Bomen Solar Farm

Response to Submissions

June 2018

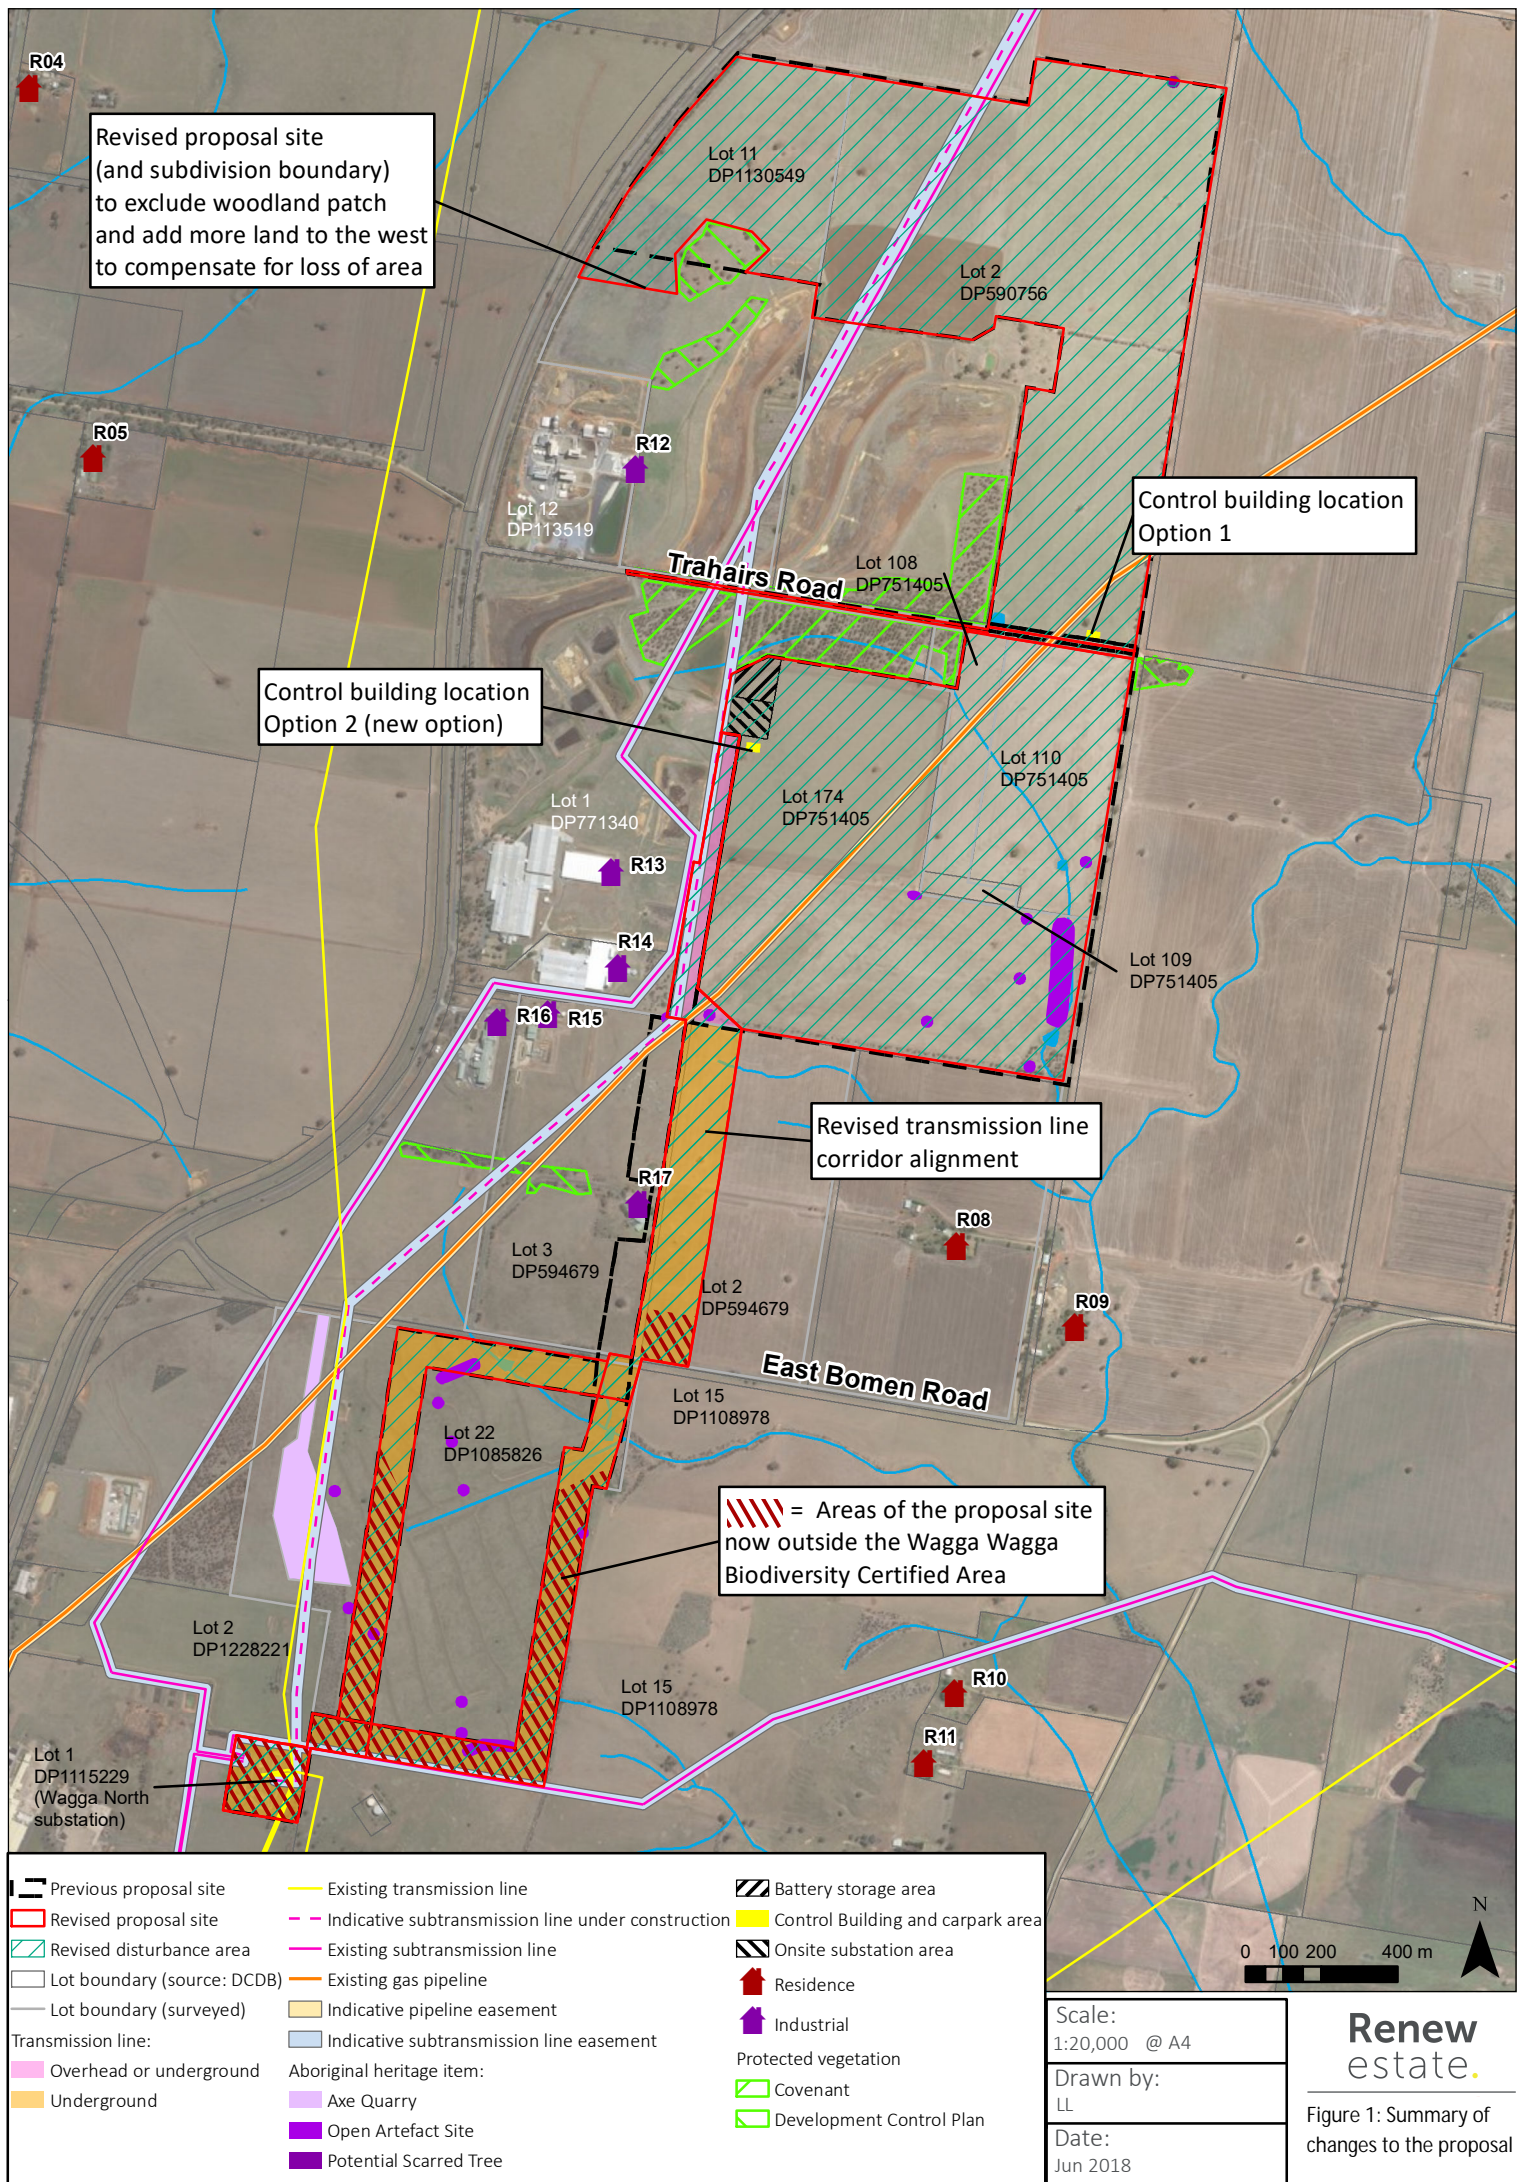
Since the preparation of the EIS, part of the proposed transmission corridor has been revised. The section of the corridor which previously was aligned along the eastern boundary of Lot 3 DP594679 has been shifted eastward across the property boundary to now run along the western boundary of Lot 2 DP594679. The previous corridor and revised corridor are shown in Figure 1.

The EIS proposed an indicative location of the control building north of Trahairs Road (refer Figure 1). An alternative option for the control building location is now proposed adjacent to the onsite substation (referred to as Option 2, refer Figure 1). The alternative location would allow for simpler linking of SCADA communication systems between the substation and control building.

Figure 2: Areas of the proposal site outside of the Wagga Wagga Biodiversity Certified Area

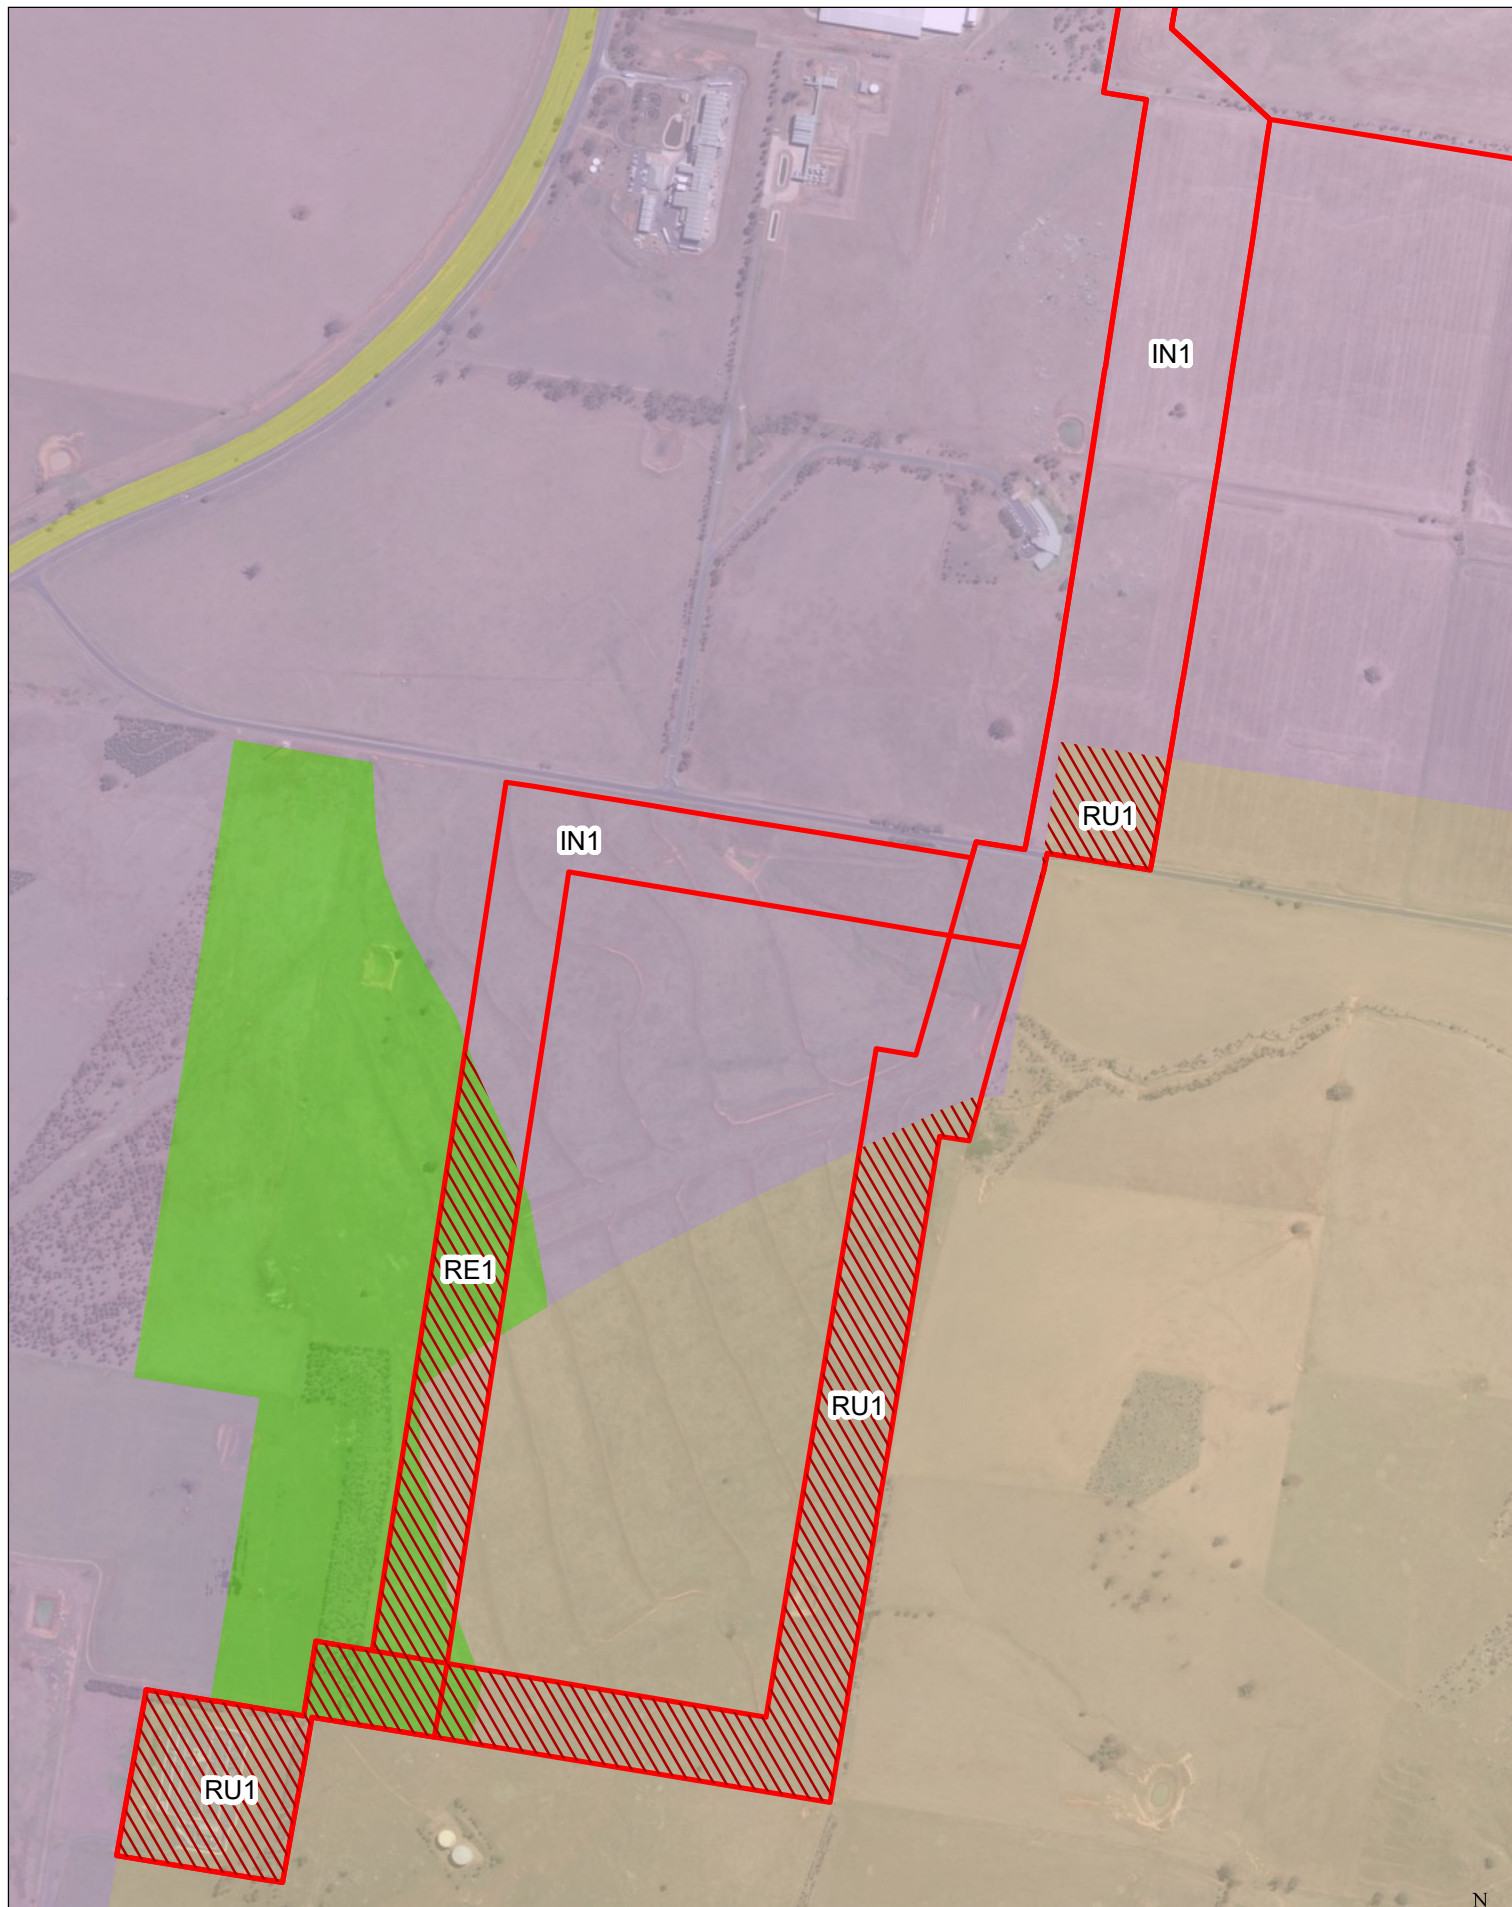
In light of the Order, parts of the proposed transmission line corridor are now outside of the Wagga Wagga Biodiversity Certified Area where the land is zoned Public Recreation (RE1) and Primary Production (RU1) (refer Figure 2). For these areas, the Biodiversity Assessment Method (BAM) applies, as established under the BC Act.

For areas where the BAM applies, a Biodiversity Development Assessment Report (BDAR) is required when vegetation proposed to be removed is classified as native vegetation, and the removal of native vegetation is required to be offset according to the BAM. For the areas of the proposal site outside of the Biodiversity Certified Area, where the BAM would apply, Renew Estate has committed to retaining all native vegetation. Therefore, a BDAR is not required to be prepared for the proposal. Figure 3 identifies all of the native vegetation within the areas of the proposal site that are outside of the Biodiversity Certified Area. The design of the underground transmission line will ensure that all of the native vegetation

identified in Figure 3 will be retained. This can be achieved through aligning the disturbance area through the existing gaps in vegetation, or through underboring,

Figure 4: Location of WWSF in relation to Bomen Solar Farm

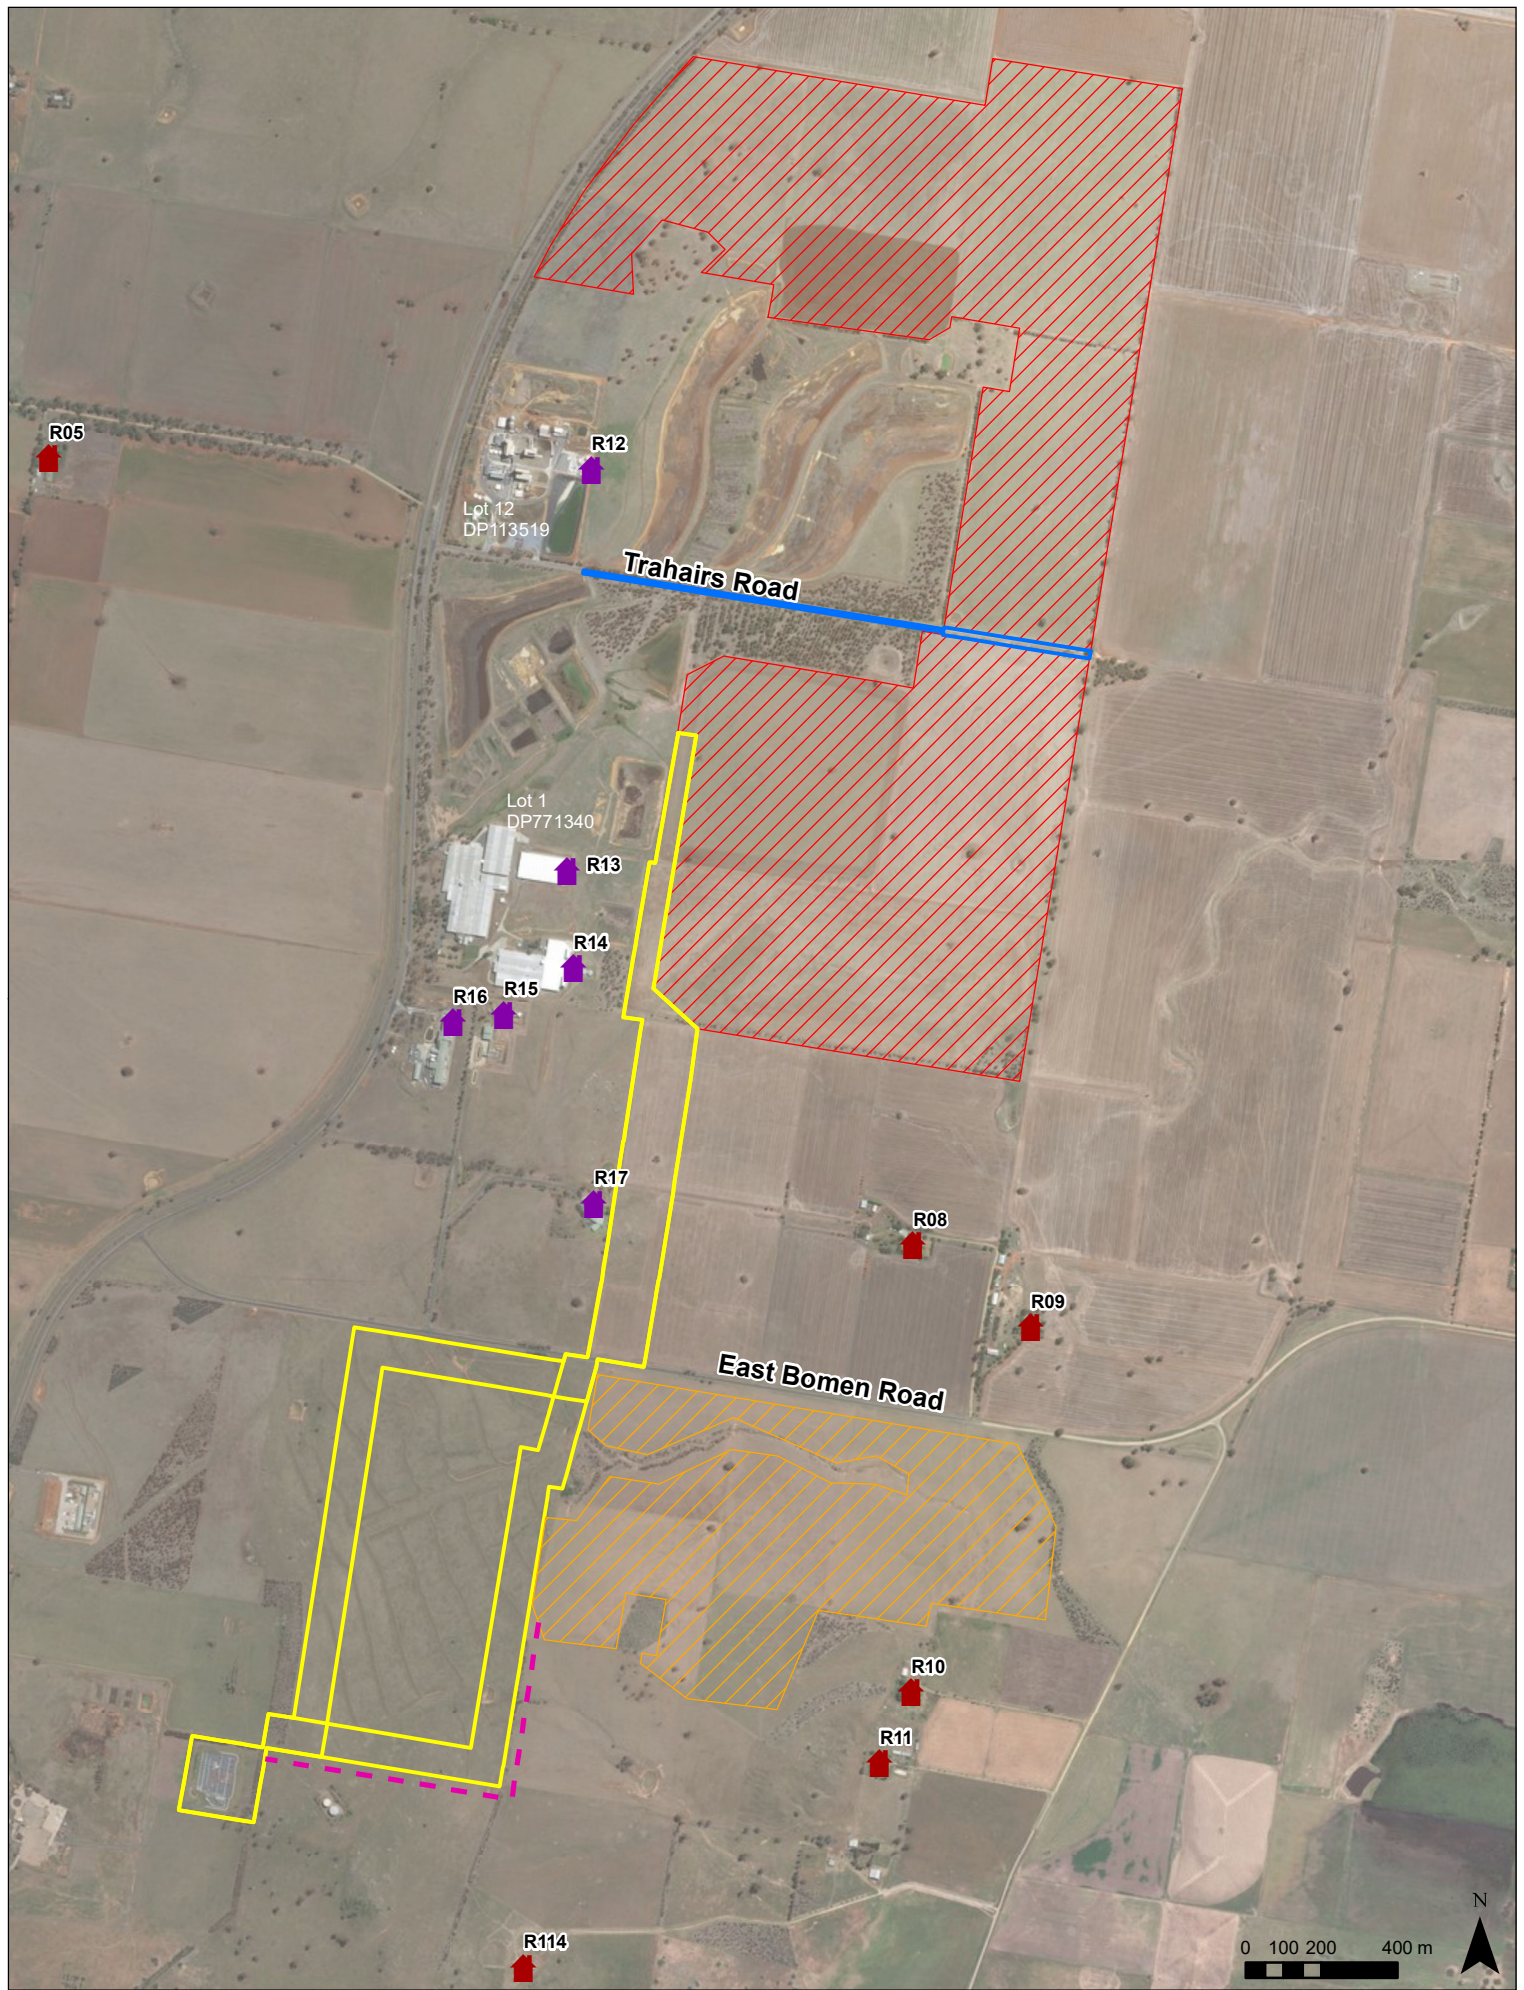
Terrain Solar Pty Ltd have submitted a development application for a 26 MWac single axis tracking solar farm and associated infrastructure, located south of the Bomen Solar Farm solar site as shown in Figure 4 (DA ref. DA17/0679). The development application is currently under assessment by Southern Joint Regional Planning Panel with its current status noted as 'Further Information Required' on the City of Wagga Wagga website.

Sensitive receivers likely to be most affected by cumulative noise impacts are residential receptors R8 and R9 (R4 and R3 in the WWSF Statement of Environmental Effects (SEE)) which are situated between the two project sites (refer Figure 4). The distance of these receptors relative to the two solar farms is given in Table 3, along with the highest predicted noise levels for each project. The highest cumulative predicted noise levels are given in the final column based on the combination of the highest predicted noise levels for each project.

The noise management sub-plan prepared as part of the Construction Environmental Management Plan will include a protocol to minimise cumulative noise impacts and will include:
